RE: SSD-9138102 Mod 3 – Request for Additional Information

ESR Developments (Australia) Pty Ltd (**the Applicant**) received a request for additional information (**RFI**) on 20 December 2023 associated with SSD-9138102 Westlink Modification 3 (**Mod 3**). To assist with Department of Planning, Housing and Infrastructure’s (**DPHI**) assessment, ESR has prepared to address matters raised by DPHI and Penrith City Council (**Council**) to enable close out of assessment.

Appendix A Extracts from Civil Design

**RETAINING WALL 1 PLAN**
SCALE 1:250

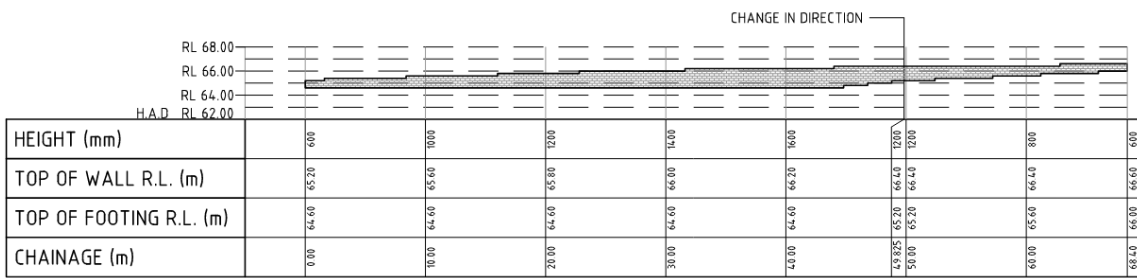
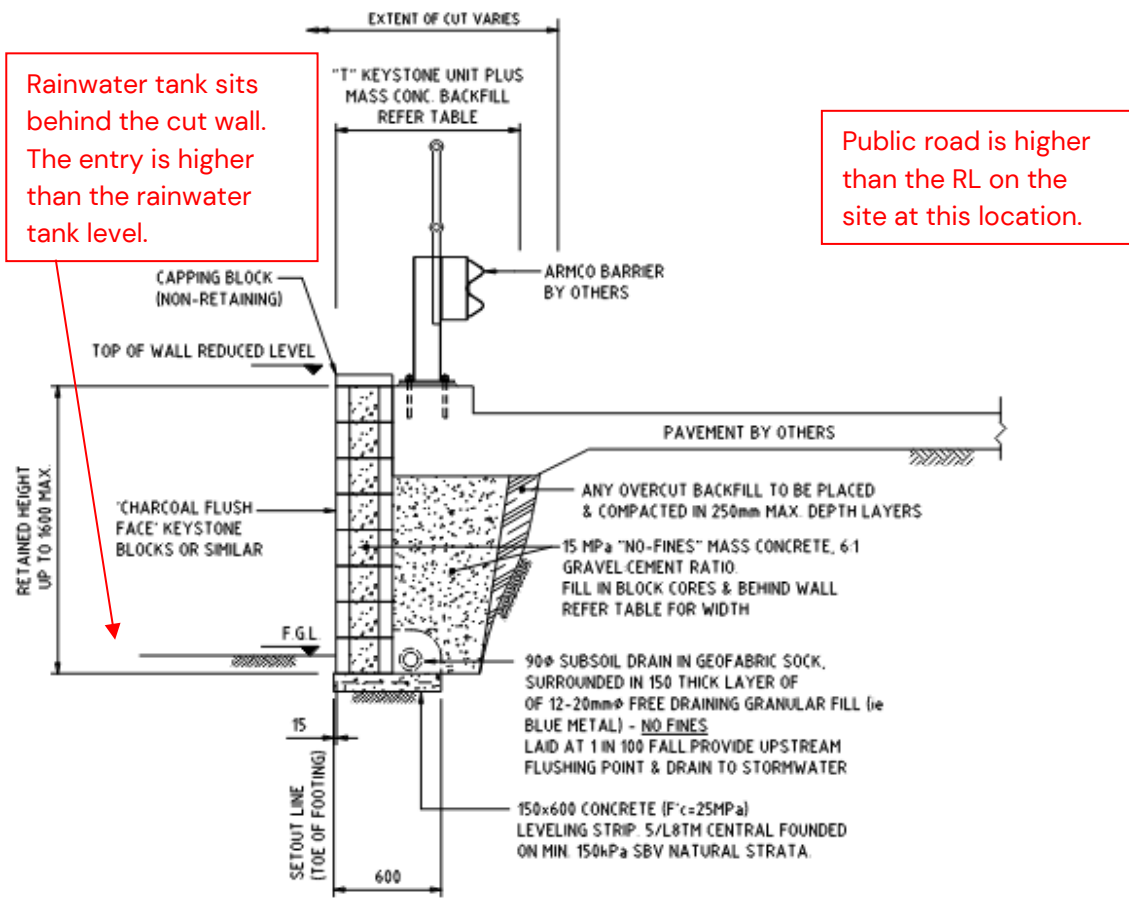
<p>and landscape areas. The proposed planting in the landscape area will screen the battery charging area from the street view. Therefore, the type of material of the battery charging stations will likely be imperceptible from the street view.</p>	
<p>The modification plans package includes a location plan for retaining wall and fencing. The plan shows a colourbond fencing 2.5m in height along the northern boundary adjacent to Warehouse 1 for the purposes of screening trucks until the retaining wall is of a height for the purpose.</p> <p>The 2.5m high colourbond fence is located at the boundary beyond the landscape screening, forward of the Aldington Road building setback, and directly abuts local heritage item 14 "brick farmhouse" at 282 Aldington Road.</p> <p>Clause 2.42 of State Environmental Planning Policy (Industry and Employment) 2021 requires the consent authority to consider impacts on heritage significance and Section 2.7 of the Mamre Road Precinct DCP includes provisions for fencing nearby heritage items. As such, these provisions shall be considered noting the fencing treatment in this location has changed from chainwire fencing to a solid colourbond fence and could result in adverse visual impacts considering its elevated nature and location next to a heritage item.</p> <p>It is noted that the proponent's modification report does not list the proposed amendment within the list of proposed modifications.</p>	<p>The MOD 4 relates to amending the retaining wall design of the cut wall, which is further east. This is a result of our neighbour's levels to the north changing due to earthworks on their boundary. The modification relates to ESR redesigning our wall to reflect the new site conditions to the north of our site.</p> <p>The colourbond fence was introduced during the assessment of the main development application. The purpose was to screen truck headlights from the neighbouring properties to the north. Assessment of heritage impacts were considered and it was concluded the screening was a preferred outcome for the Precinct.</p> <p>There are no other changes associated with the retaining walls on the site. The fill wall along Aldington Road and the northern boundary, which includes the colourbond fence, are not proposed to be amended from the existing consent under this modification application or MOD 4.</p> <p>Therefore, the comments raised by Council are not relevant to the assessment of this modification application.</p>	<p>N/A</p>
